31/07-04 2805 Beechbank Road
Capitol View Park Historic District

TREE PRESERVATION PLAN FOR 2805 BEECHBANK RD

SUBJECT: Historic Area Work Permit #353422, New House Construction

Address: 2805 Beechbank Avenue (Capitol View Park Historic District)

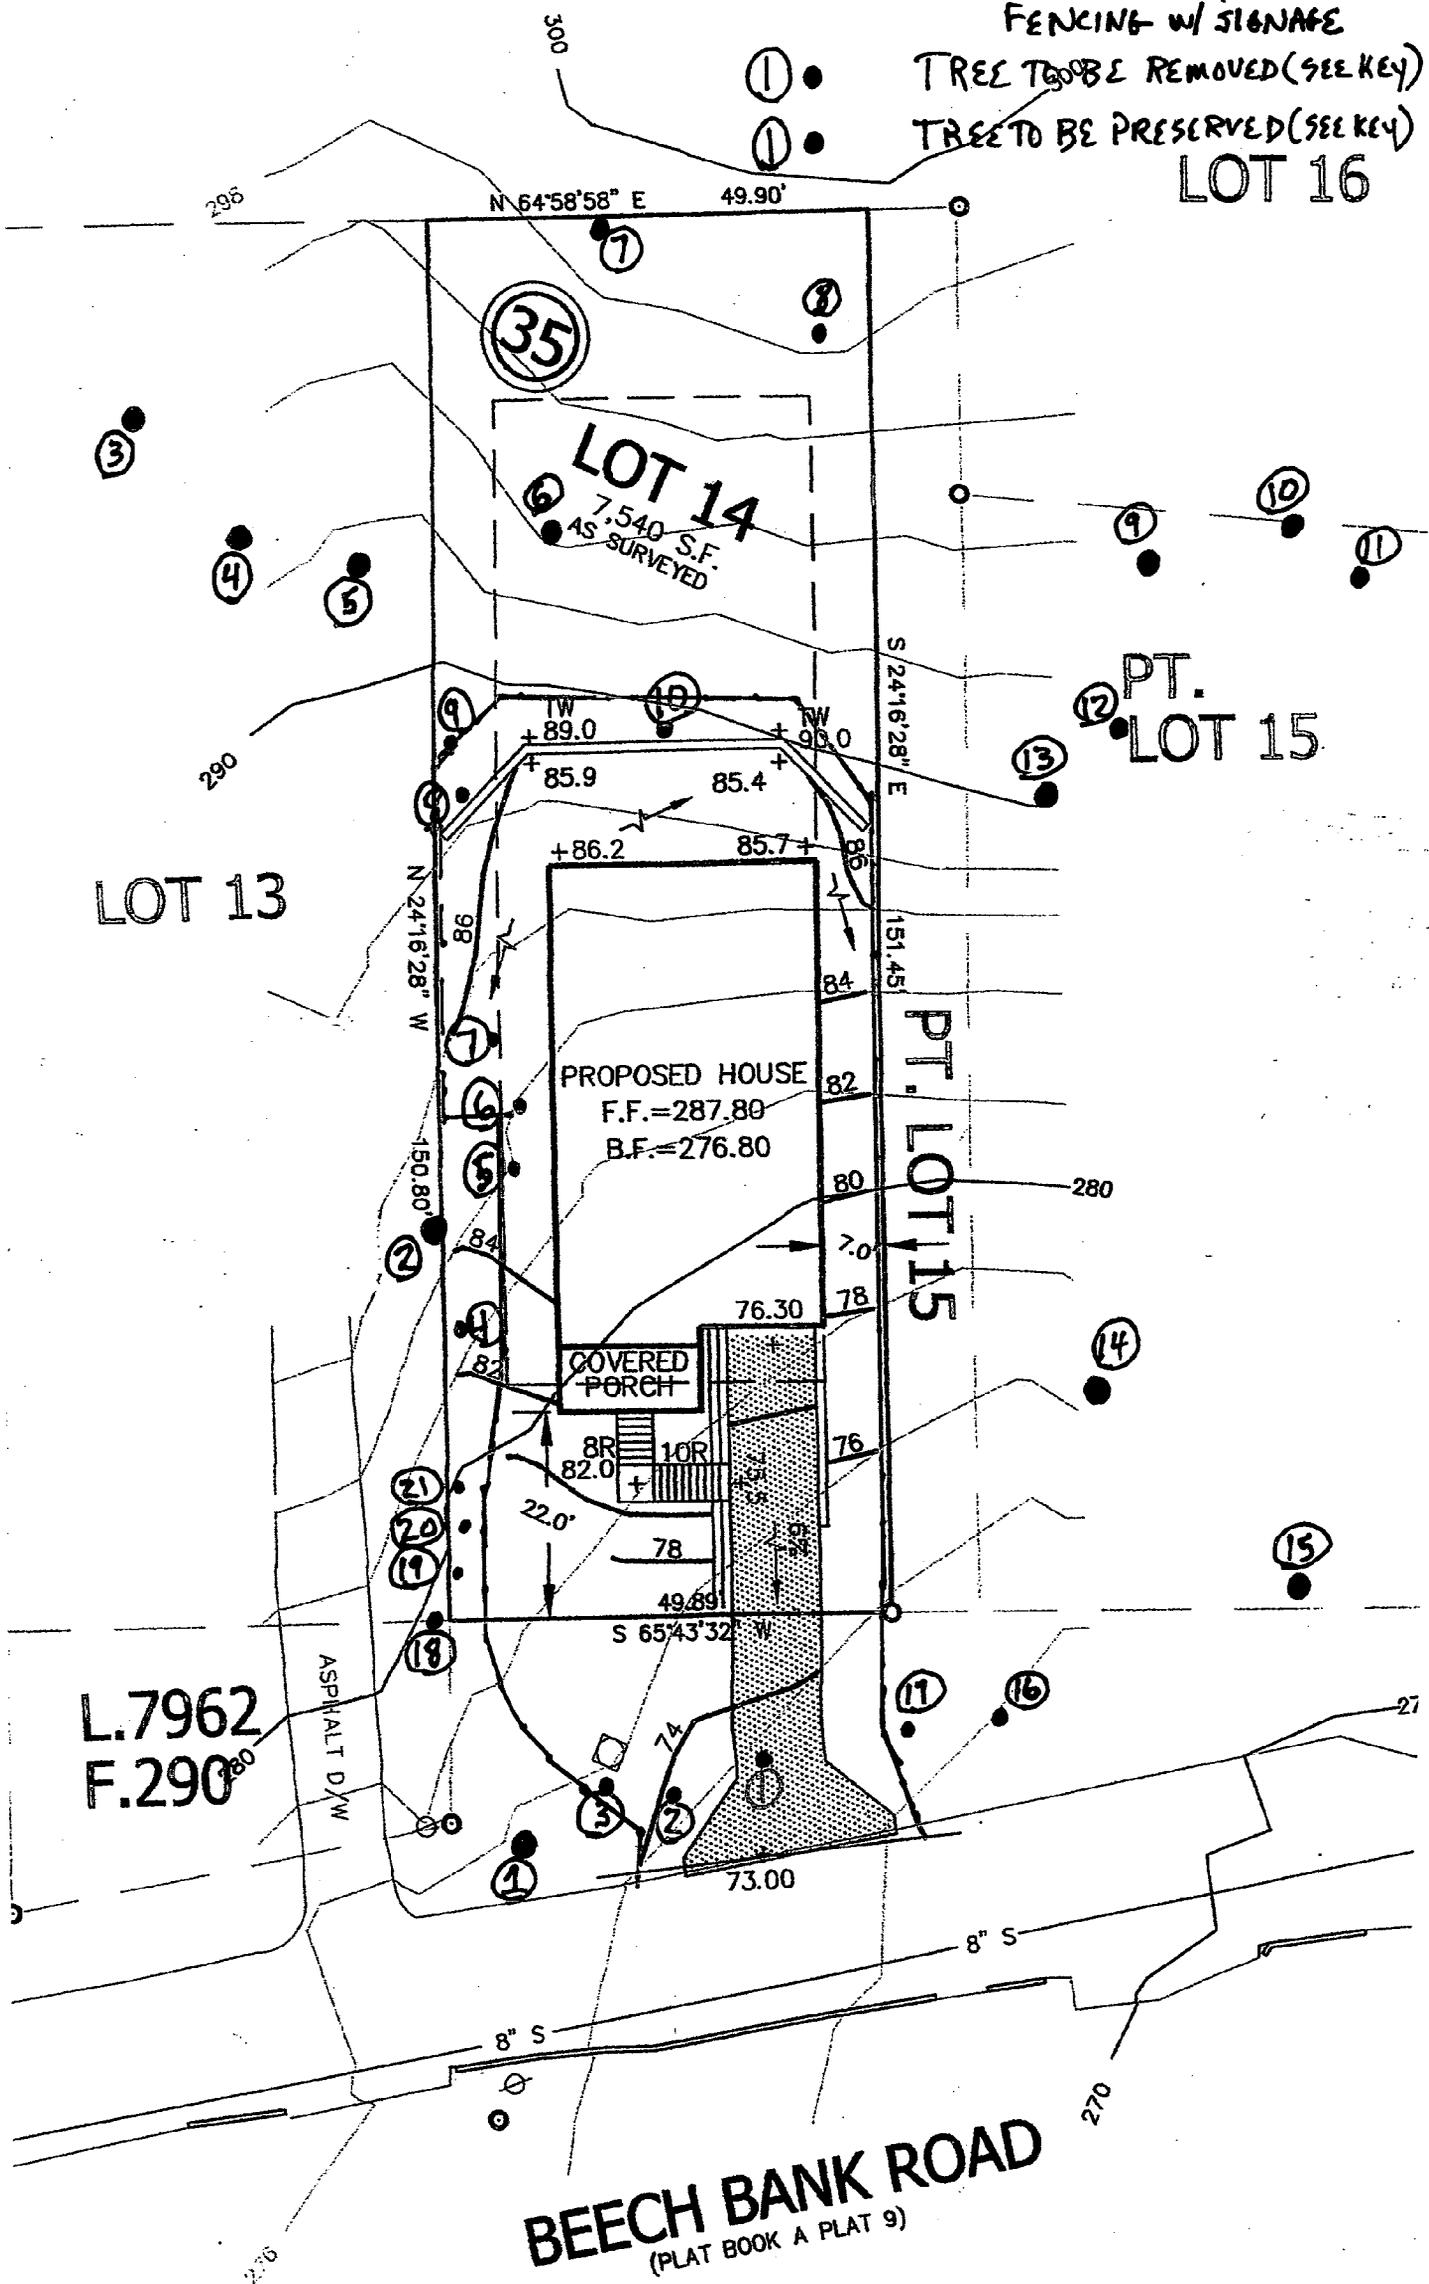
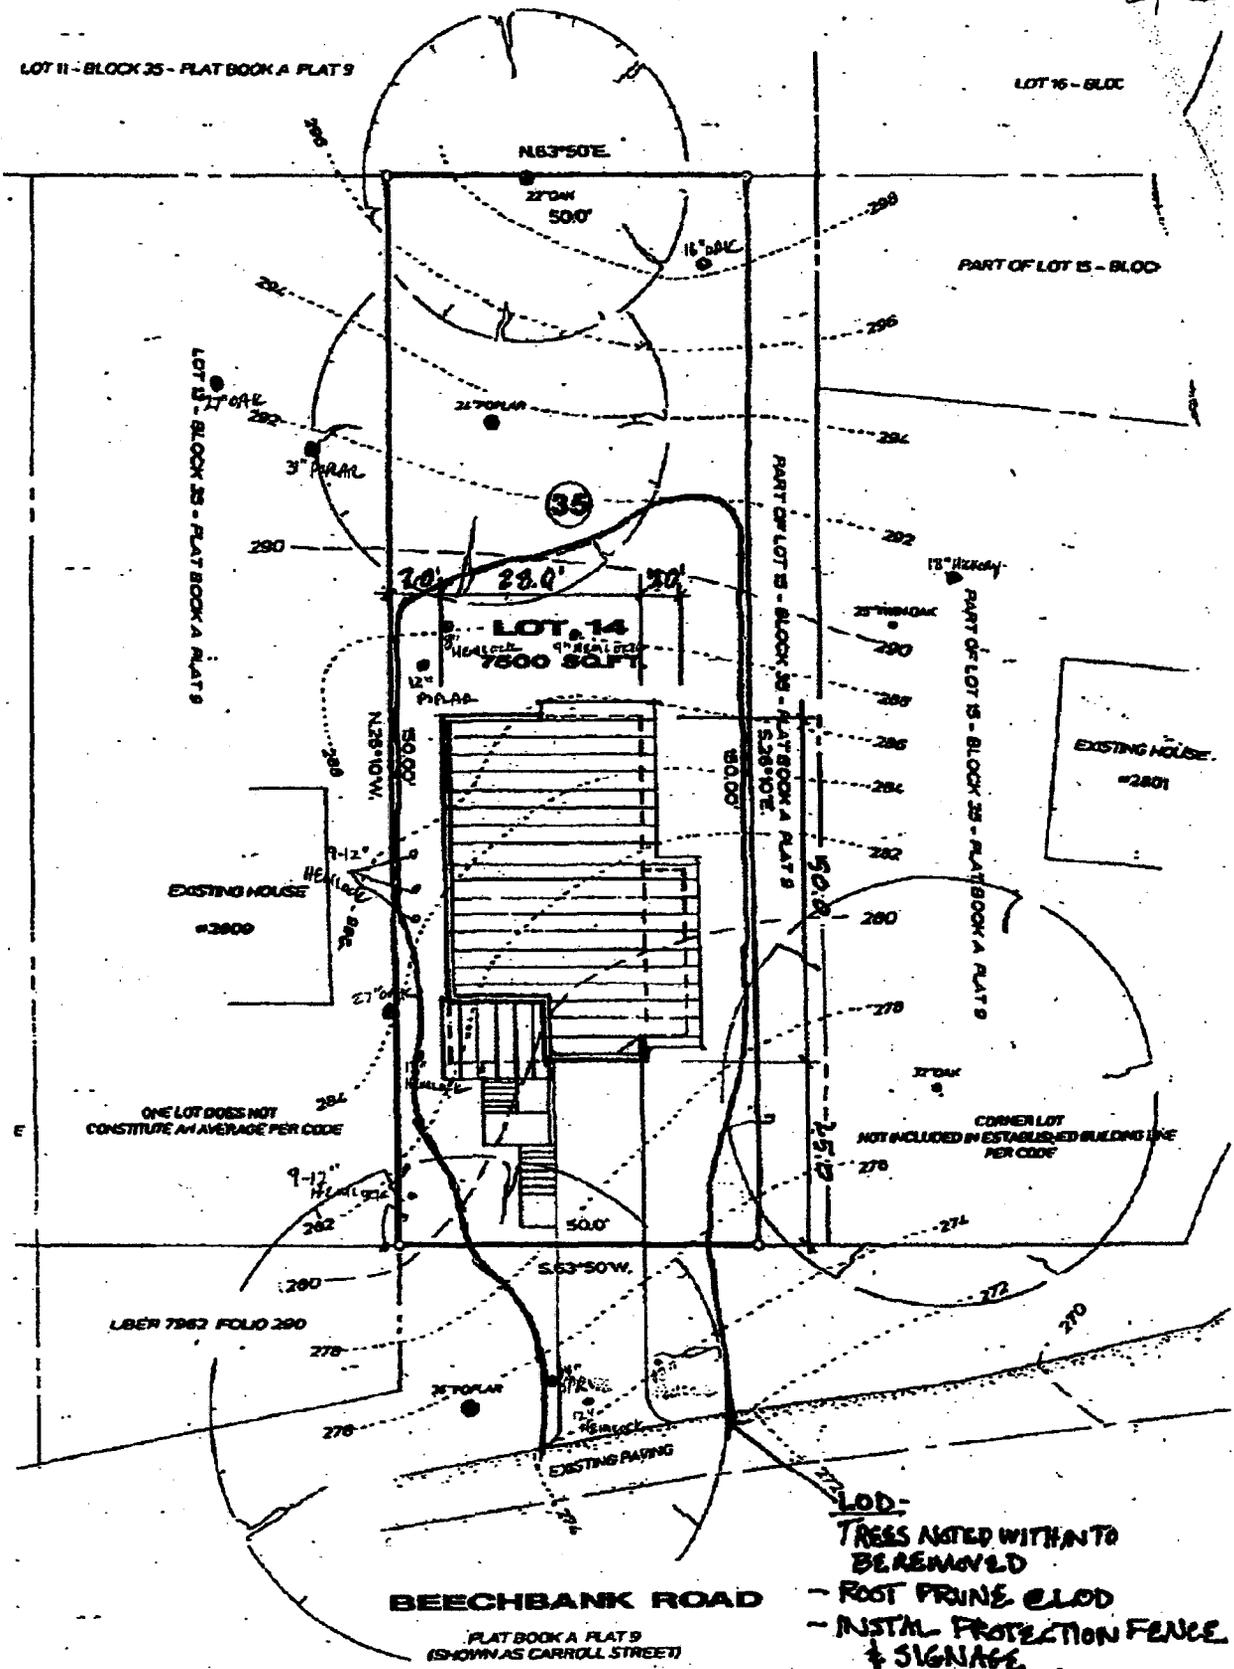
LDVM for David
Kahn. Neighbor
Graham Wistow called
re: tree protection.

2. A tree survey identifying trees larger than 6" in diameter DBH will be conducted and submitted to staff for their review. The survey will include notations indicating which trees are to be saved and removed from the site. For the trees to be saved, a tree protection plan, drafted by a certified arborist and reviewed and approved by staff prior to the stamping of the permit set of drawings. The tree protection plan will outline the protection measures that will be implemented to ensure the survival of these trees during and after construction. If the plan identifies the removal of a tree larger than 6" in diameter, the plan will be submitted to the Commission for their review and approval.

- SUPER SILT FENCE - LOD - TREE ROOT PRUNE & PROTECTION FENCING w/ SIGNAGE
- ① ● TREE TO BE REMOVED (SEE KEY)
- ② ● TREE TO BE PRESERVED (SEE KEY)

- LOD - TREES NOTED WITH 'N' TO BE REMOVED
- ROOT PRUNE @ LOD
- INSTL. PROTECTION FENCE & SIGNAGE
- 6-8" MULCH APPLIED

SITE / ROOF PLAN

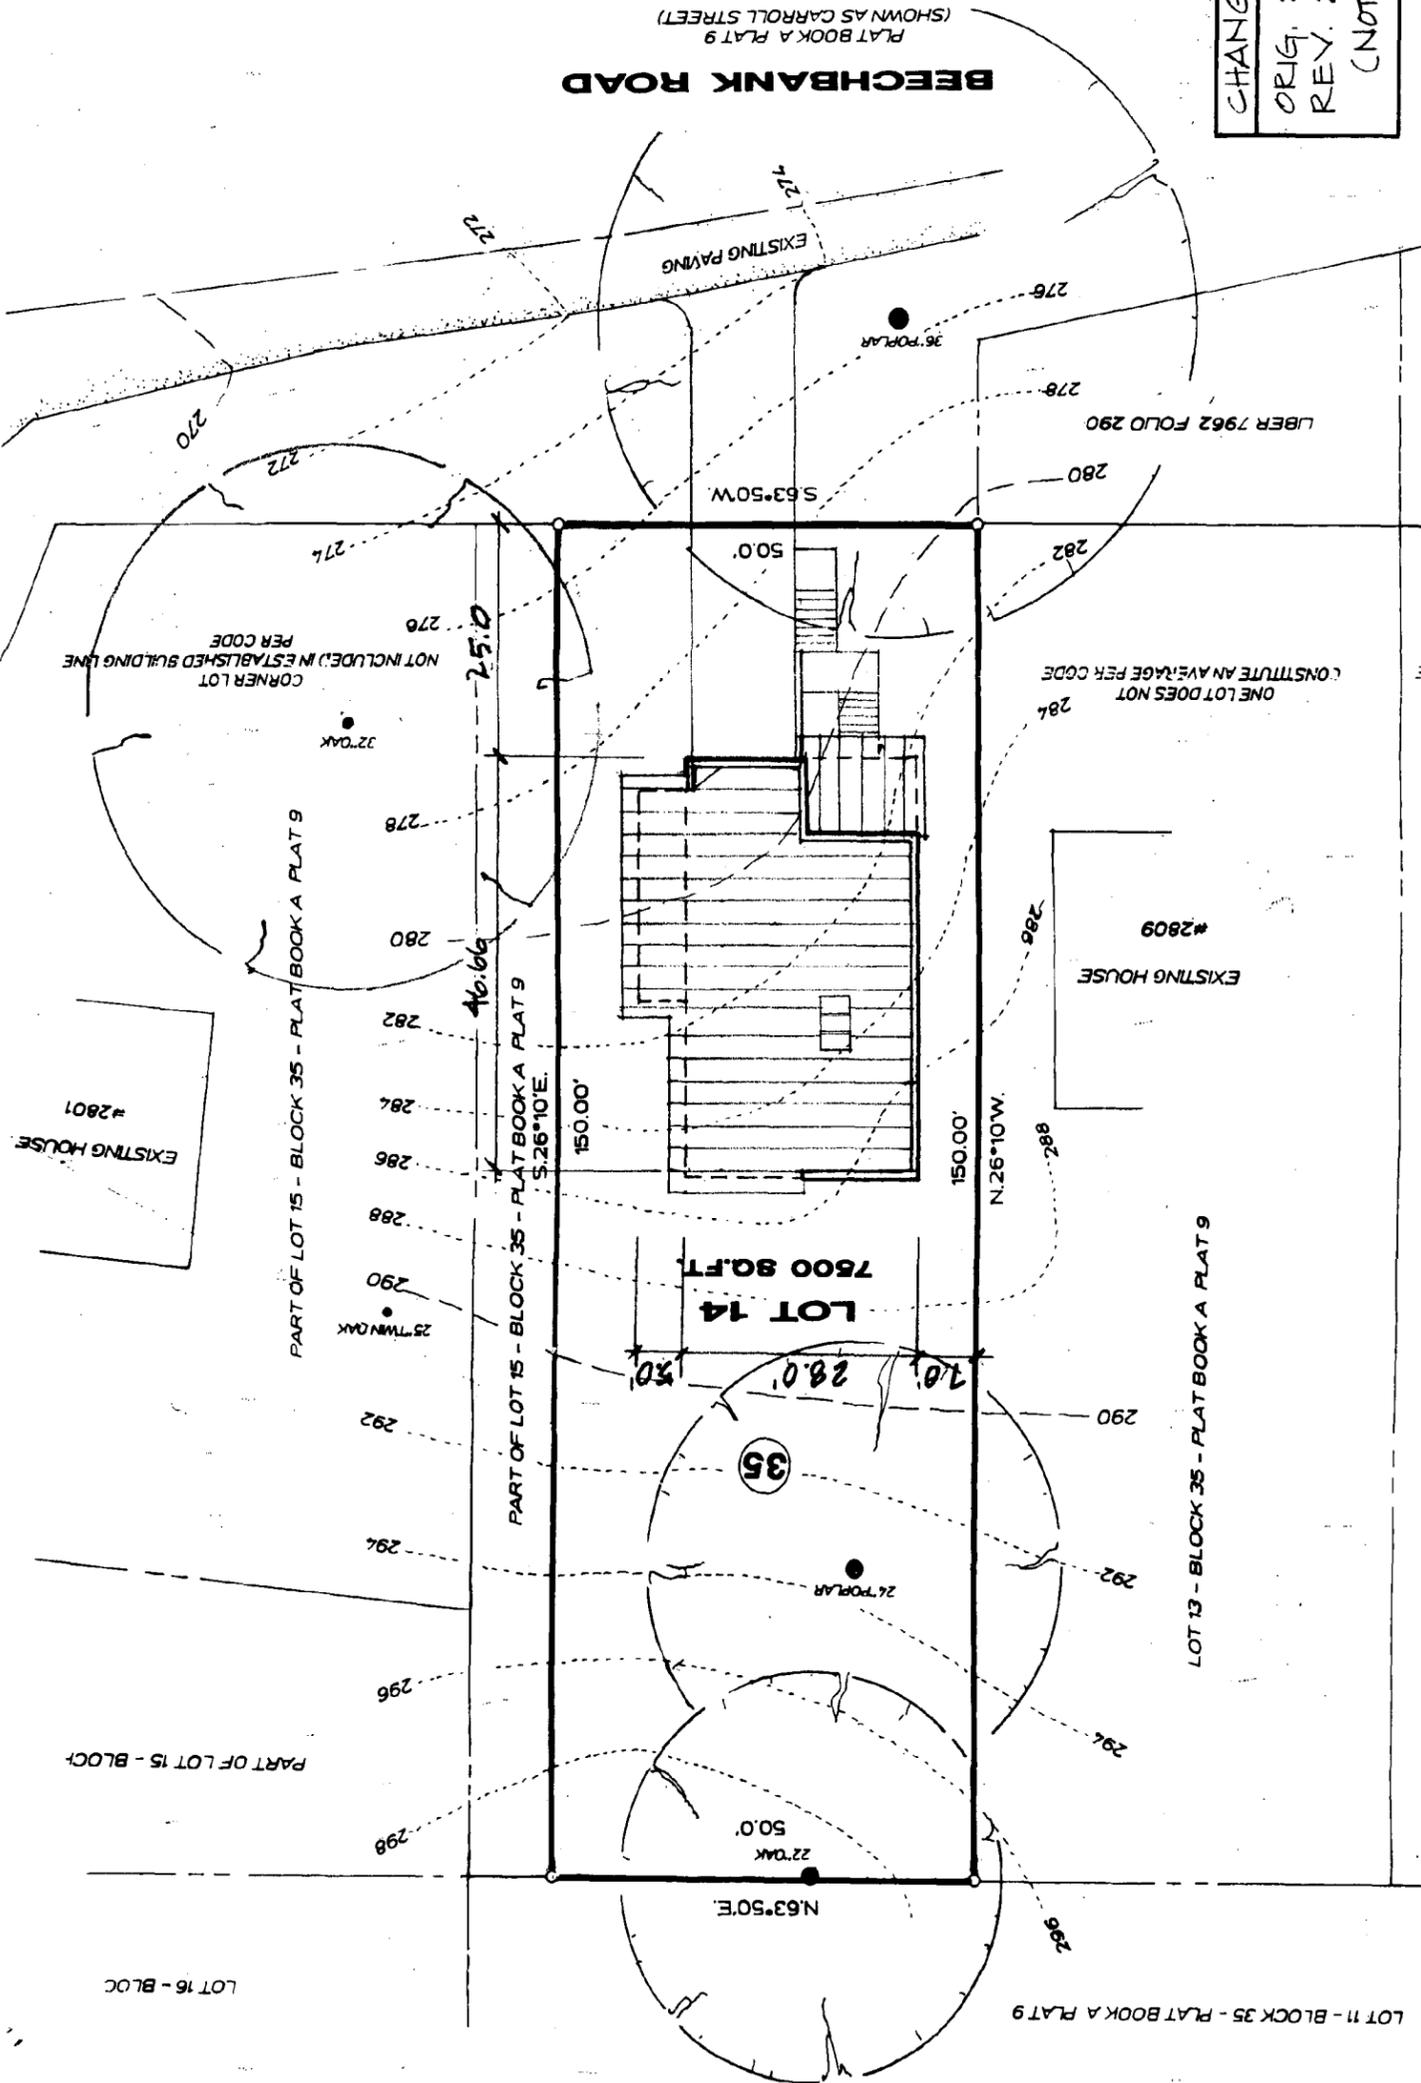
15 The only concern that we had was in the proposed
16 footprint of the subject house. I will note, however, on
17 the site plan that you received in your packet, it's a
18 little misleading visually because as you'll note in the
19 drawings on the easel, there is a cantilevered section that
20 has been illustrated on the site plan that is actually not
21 part of the footprint, so the footprint will actually be
22 this dotted line that extends from the side elevation
23 straight down. So, there is a little bit more room there
24 visually, but the numbers in the staff report do reflect the
25 footprint as is. There is no modification on that, but I

1 think visually in terms of the goal of the Staff and the
2 direction that they gave the applicant is to try to set it
3 over as far to the west as possible, and I think that is
4 achieved if you eliminate that visually from the site plan.

13 MS. NARU: Right. If you look on your site plan,
14 the existing house to the west is identified and we really
15 wanted them to keep this massing consistent with the
16 streetscape towards the west. And you'll note that the
17 other houses along the street are also that 25-foot setback,
18 because they're all non-contributing infill development.
